NO.	DATE	BY	DESCRIPTION
1	7/24/18	TMO	ADD TREE WELL AND REVISE NOTE
2	7/15/19	TMO	ADD SHOULDER VALLEY GUTTER AND FLUME

9/19/2019 Site Conditions

CITY OF AUSTIN
NORTHERN WALNUT CREEK HIKE AND BIKE TRAIL PHASE 1-A
PLAN AND PROFILE
STA 14+50 TO STA 18+50

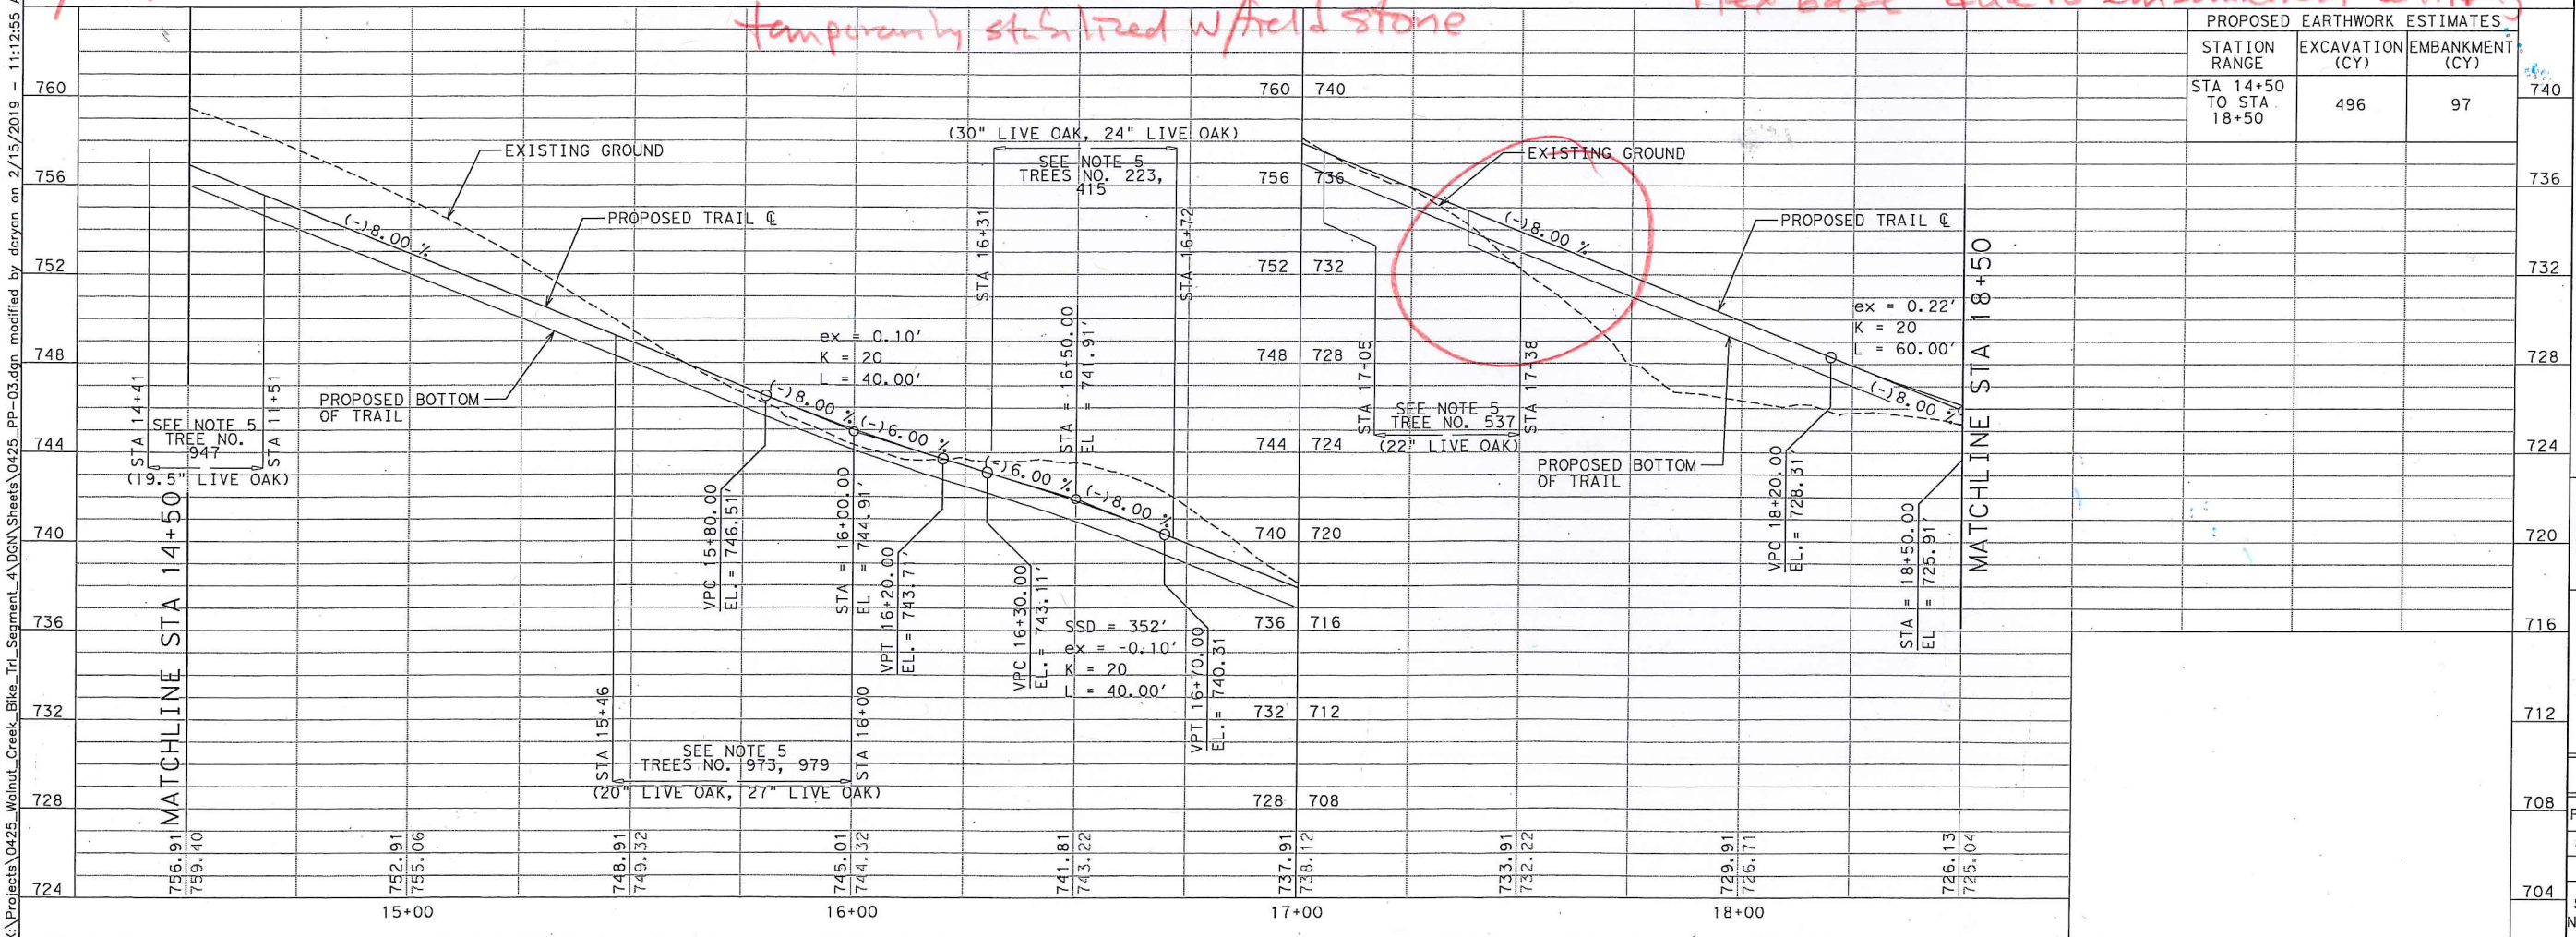
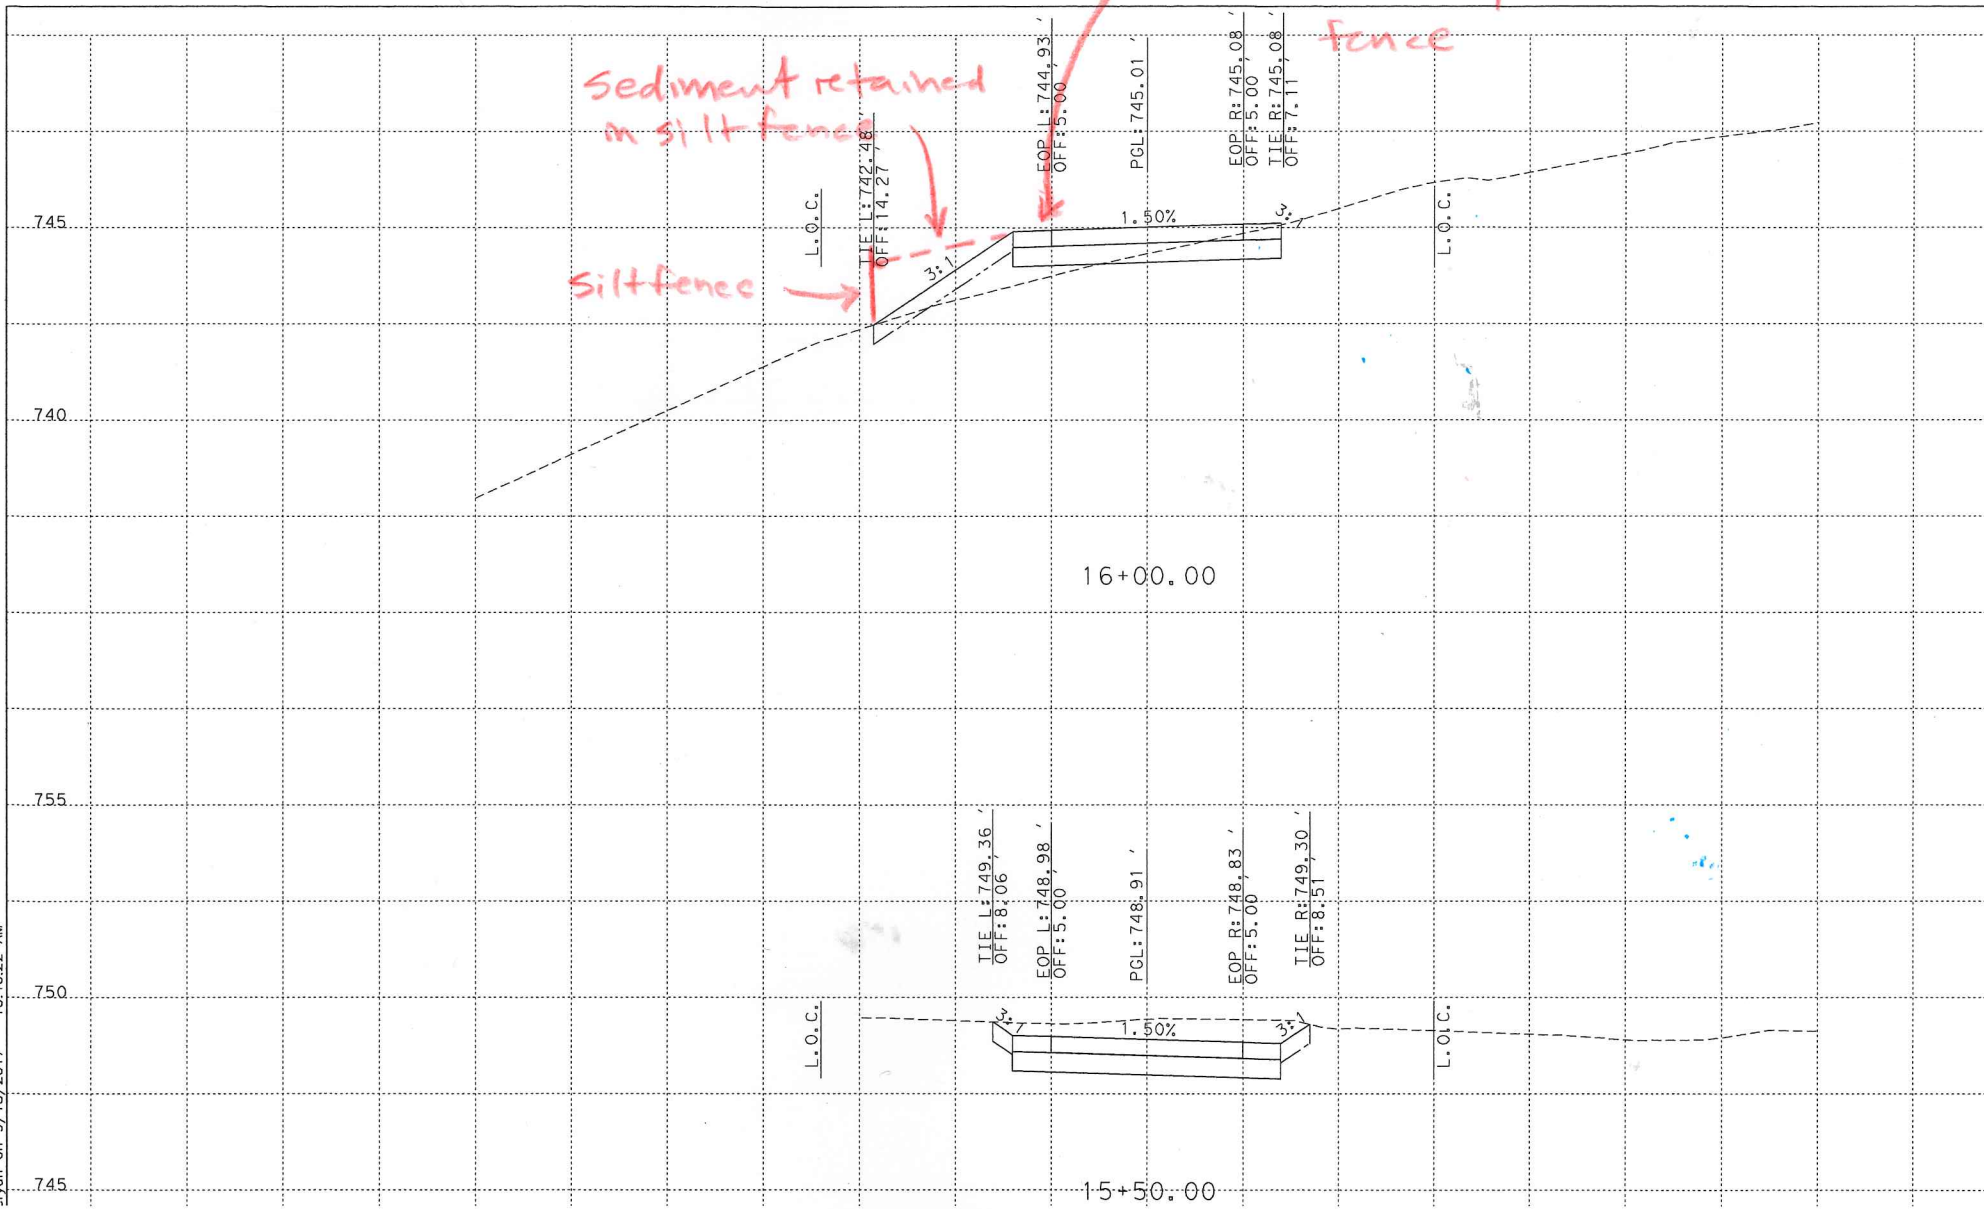
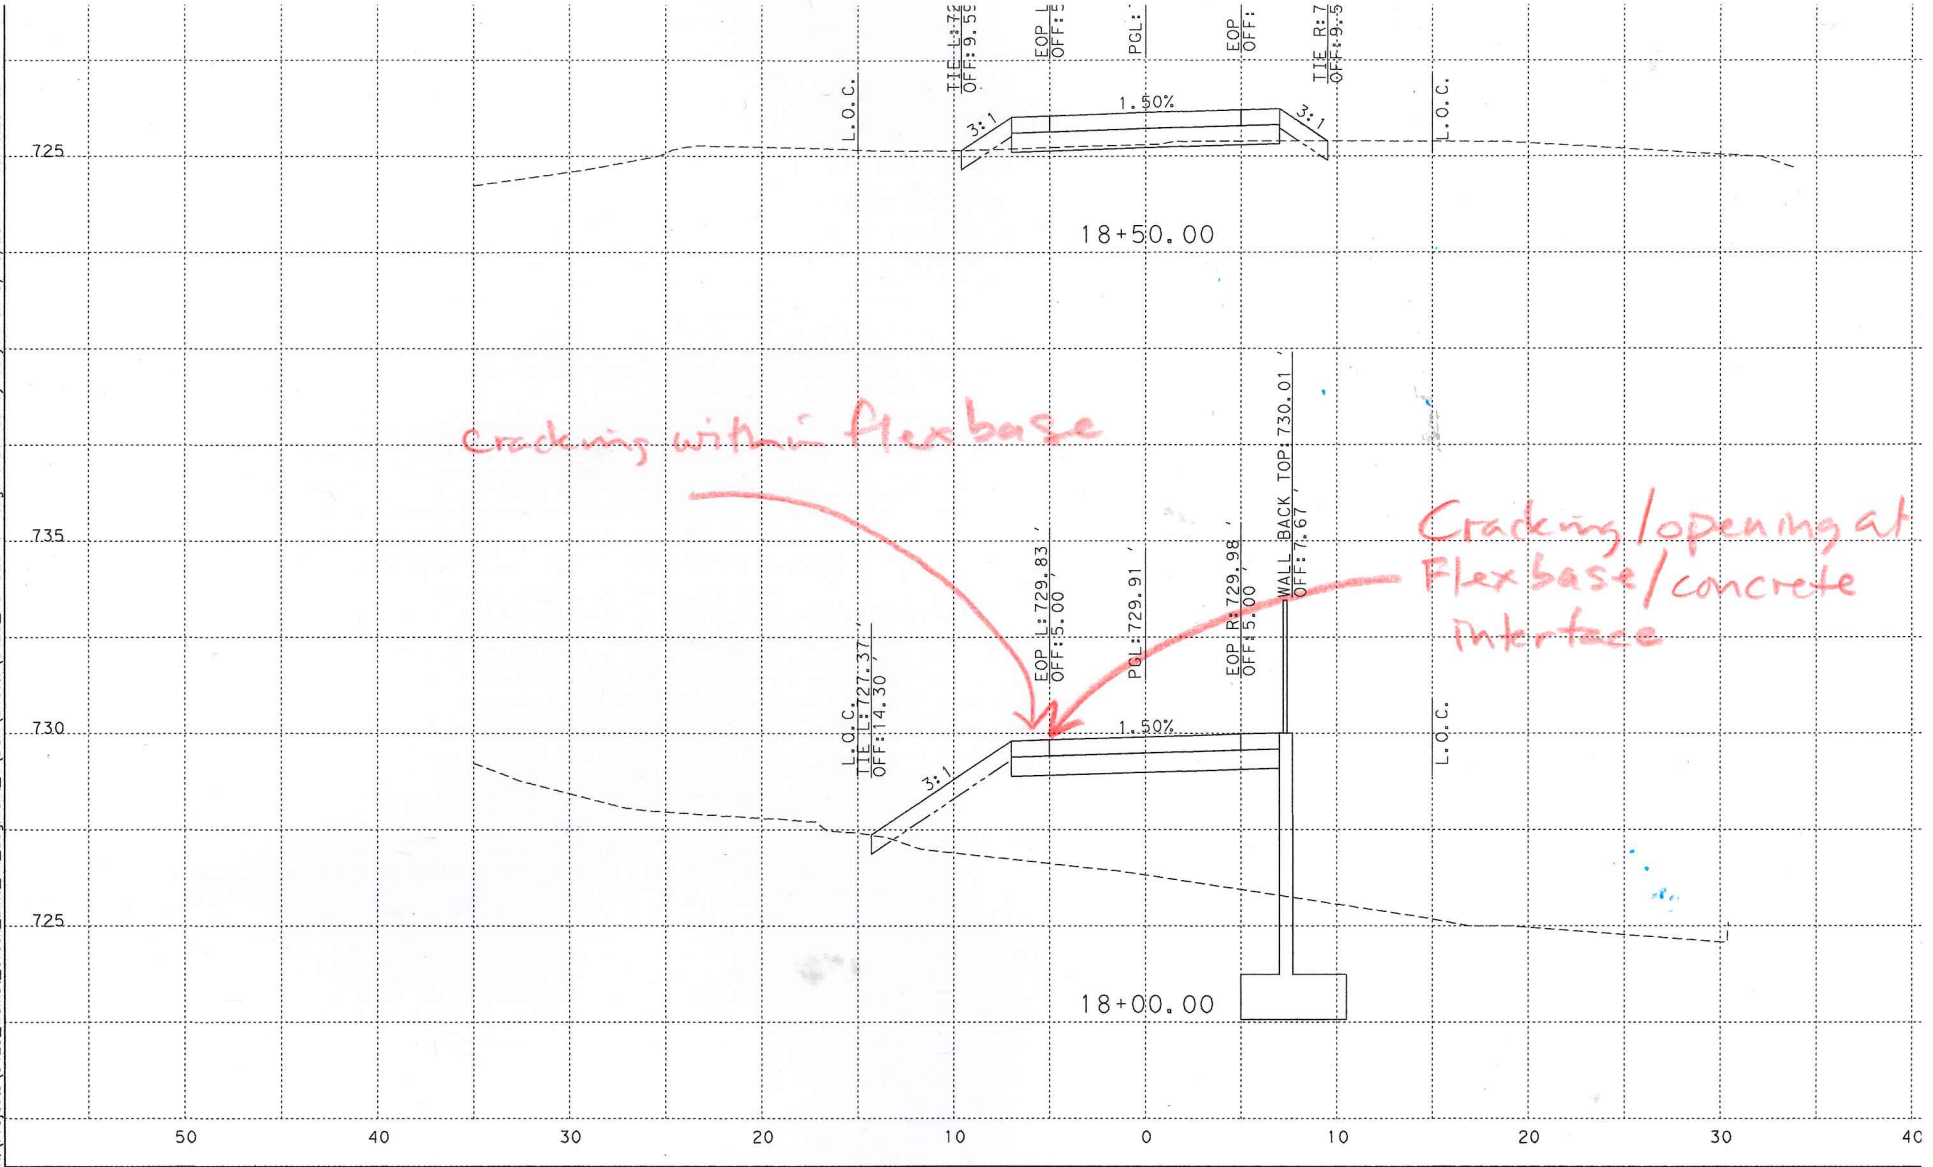
Flume added
due to complete
failure of
shoulder
section

From STA 11+00
Flume washed out of aggregate

This area
to have flex
base replaced
w/ top soil

Silk Anne
Supporting 18" x 4"
eroded material
Base has aggregate
exposed & migrating
down slope

Base has separated from edge of concrete
& longitudinal cracking within
flex base due to embankment settling

Severe loss of flex base
temporarily stabilized w/ field stone

Cracking within flex base

Cracking/opening at Flex base/concrete interface
